## ROCHESTER BRF 0162(17) – BRIDGE NO. 16

### TEMPORARY SIGNAL PLAN SUBMITTAL

**RE:** Temporary Signal Plan Submittal received from Schultz Construction on 7/23/2014.

### Bridge 16 Temp. Signal Plan

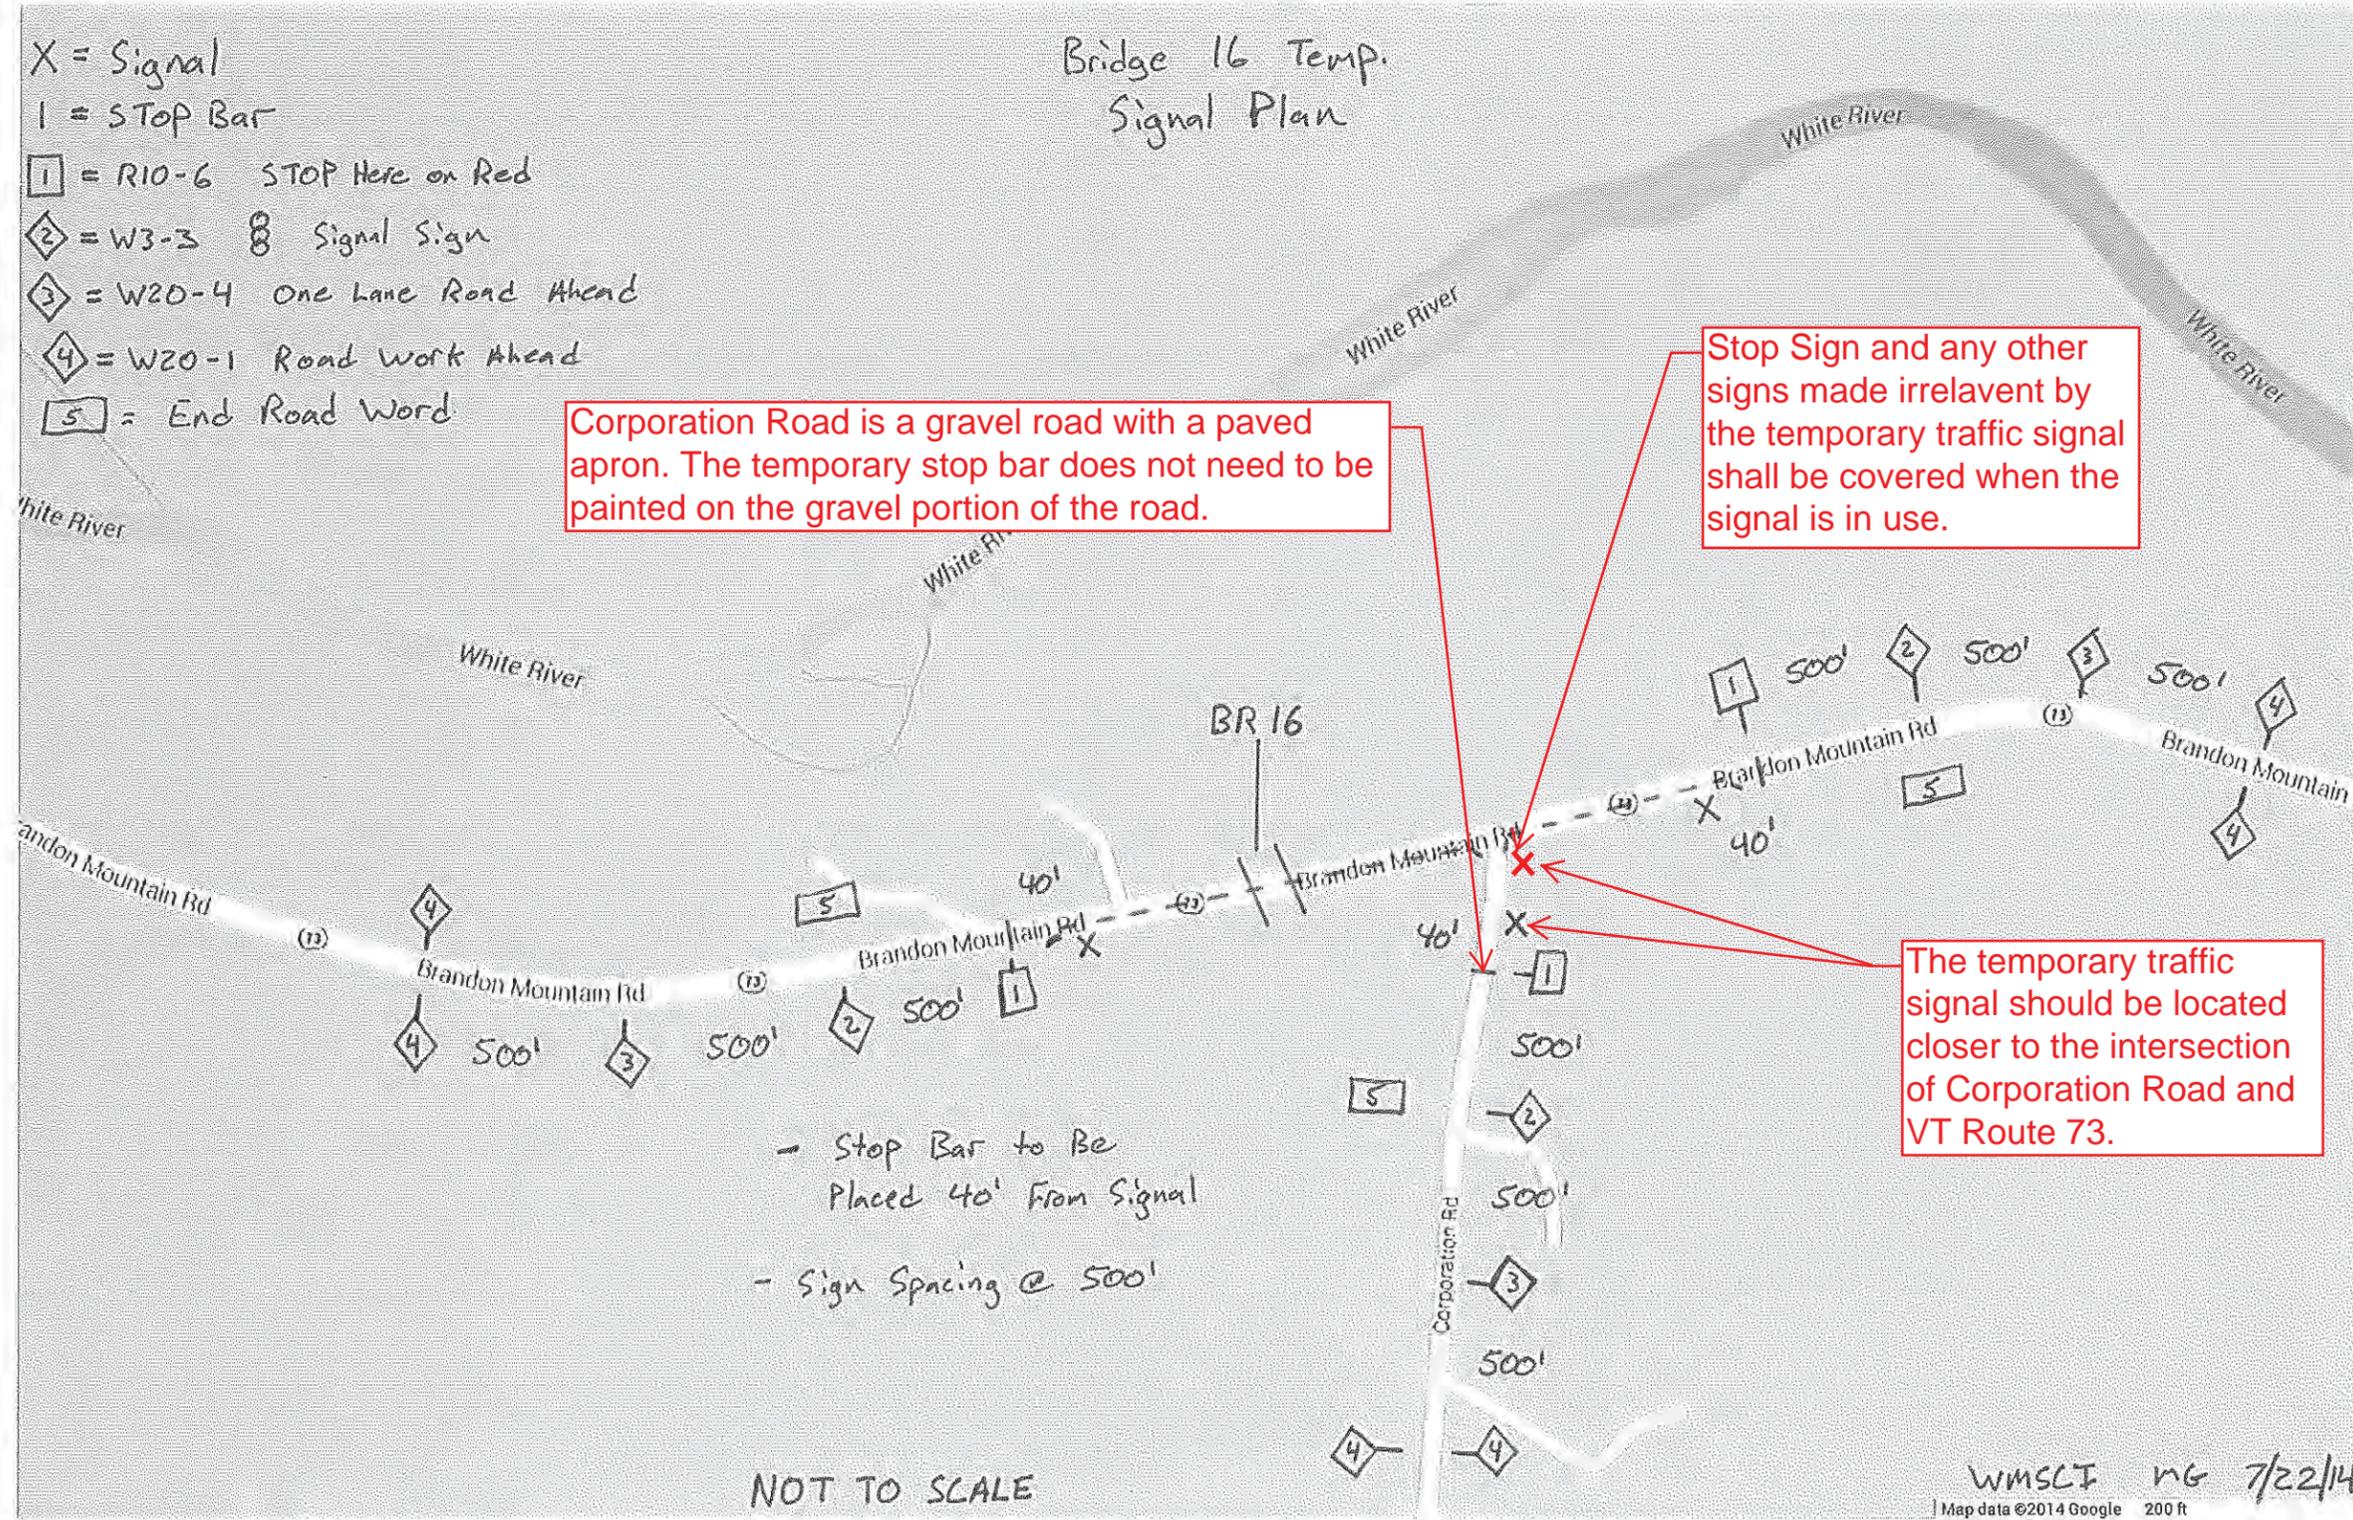
Corporation Road is a gravel road with a paved apron. The temporary stop bar does not need to be painted on the gravel portion of the road.

Stop Sign and any other signs made irrelevant by the temporary traffic signal shall be covered when the signal is in use.

The temporary traffic signal should be located closer to the intersection of Corporation Road and VT Route 73.
